TRANS/WP.29/2000/58  
22 September 2000

**PROPOSAL FOR DRAFT O3 SERIES OF AMENDMENTS TO REGULATION No. 49**

(Emissions of C.I., NG and P.I. (LPG) engines)

Transmitted by the Working Party on Pollution and Energy (GRPE)

Figure 2: Conformity of production testing scheme"

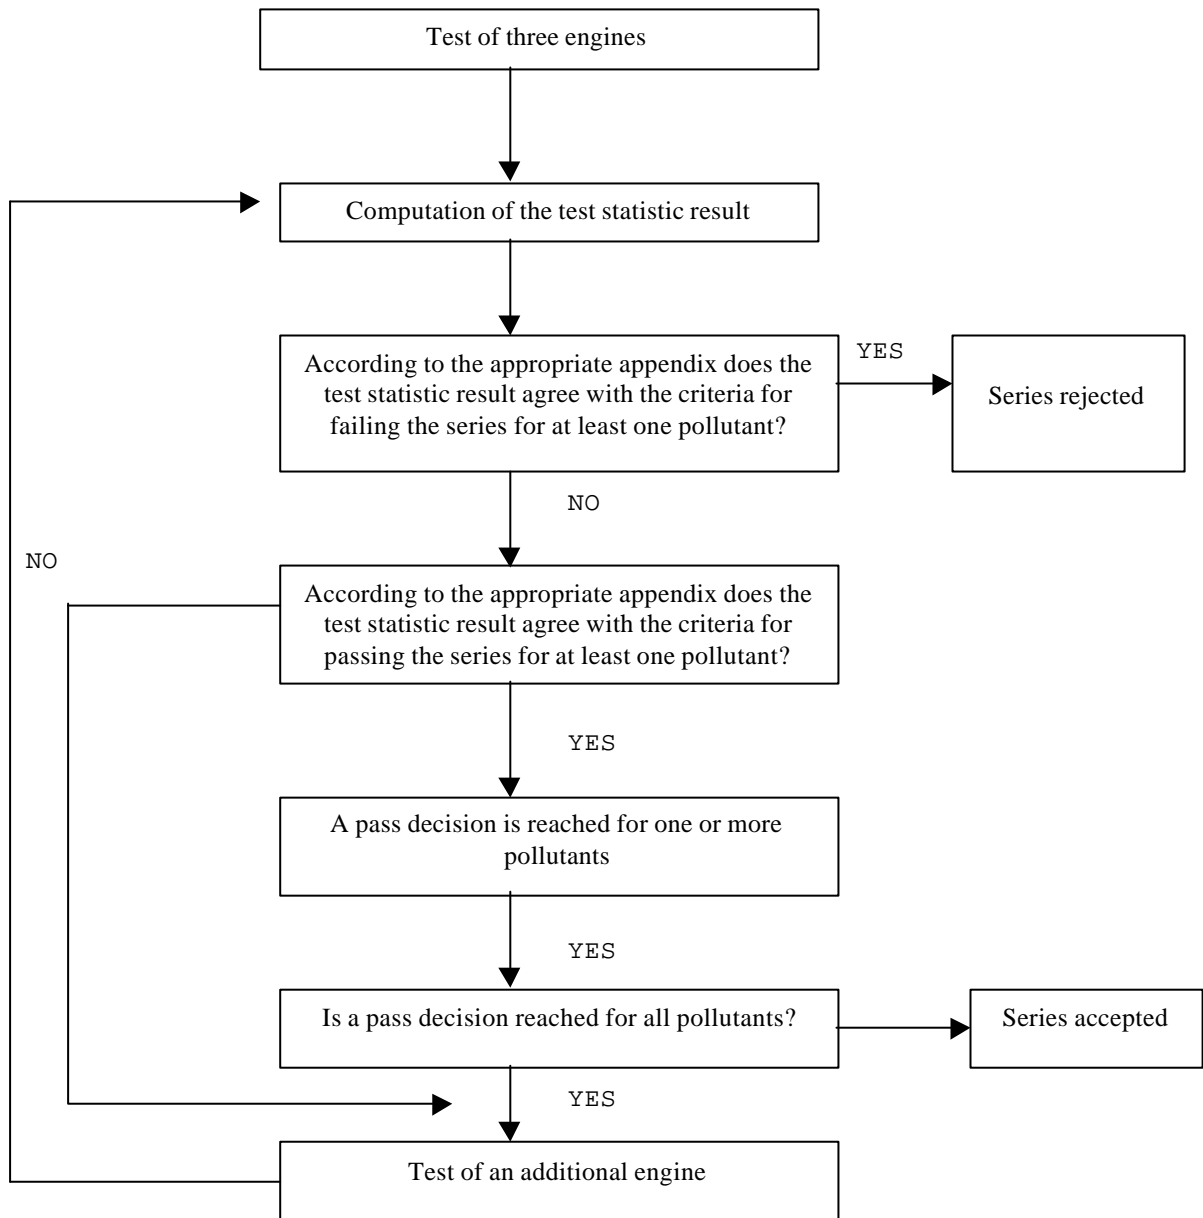
Paragraphs 7. to 7.4.4., replace by the following text (paragraphs 8. to 8.3.2.6., including also new Figure 2):
